A 6760 replaces UES 815S

Product Information

New A 6760 Power Supply

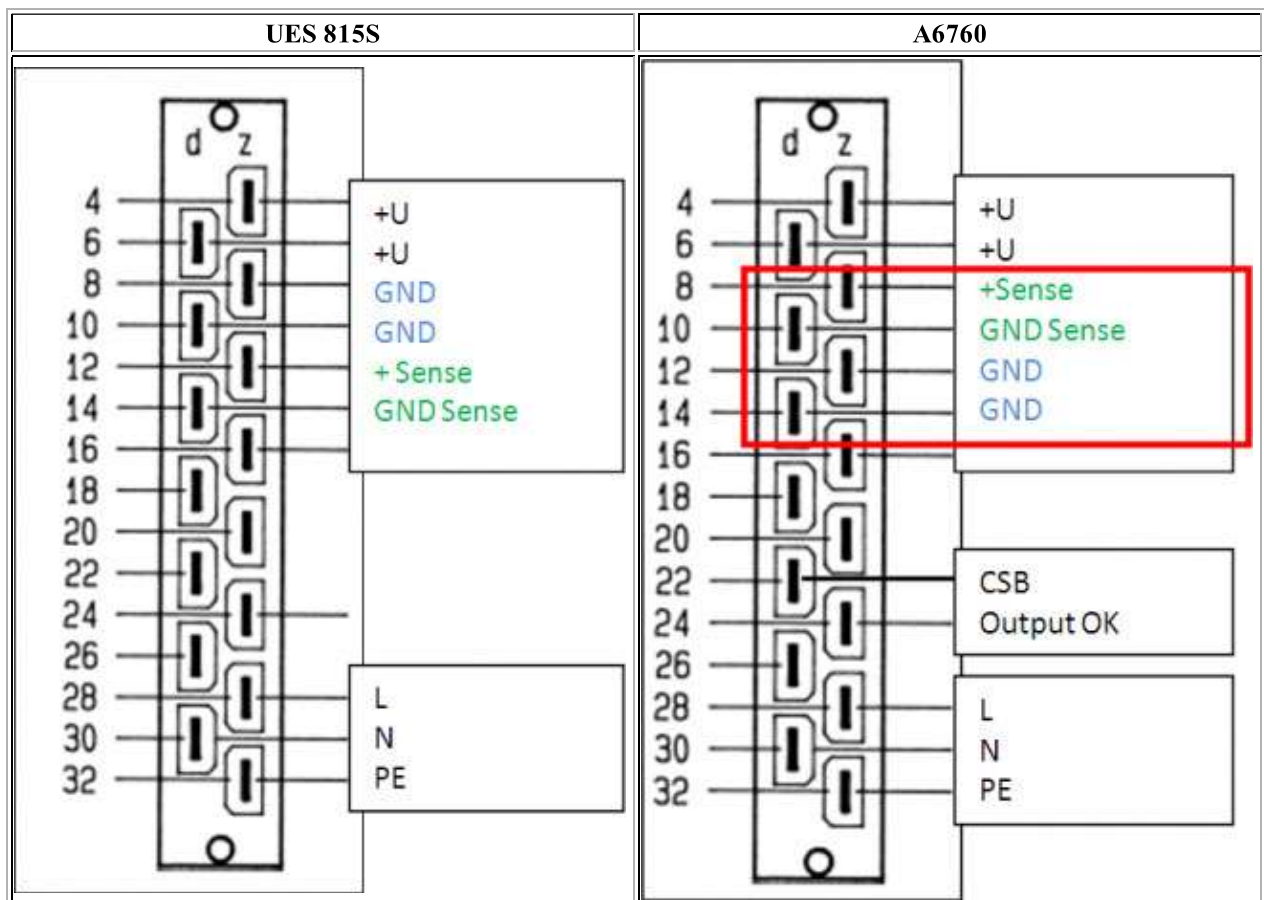
With immediate effect, the new power supply A 6760 replaces the old UES 815S. Both power supplies have the same mechanical dimensions and the main electrical data of the A 6740 exceed the data of the UES 815S. The major difference between the power supplies is the pin allocation on the rear side.

If an old UES 815S has to be replaced, it is definitely necessary to change the existing wiring according to the diagrams shown below.
